Access Compliance Report

Public Rights-of-Way

(Curb Ramps)

Intersection ID: 29139	Main Street: BALSAM_TREE_DR	Cross Street: STONEY_VALLEY_CT	Location: NE
ADA ID: 61330538EFB3	Ramp Type: BlendTrans1	Initial Pass/Fail: Pass	Overall Compliance: No
Severity Score: 10			
Codes/Mitigation Info/Possible Solution		Field Measurements/Component Compliance

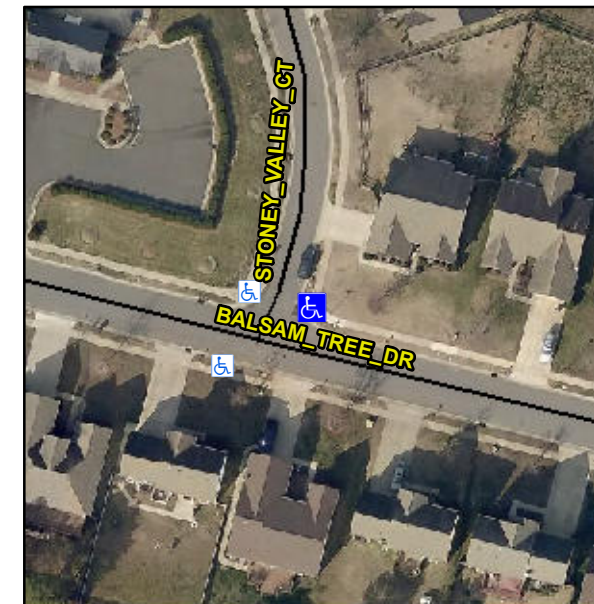
Surveyor Notes:

N/A

PROW/ADA:

R304.2.2-Perp, R304.3.2-Para, R305, R302.3, R402.2

Remove & Replace Curb Ramp With Two New Directional Ramps or Equivalent. Utility Present.
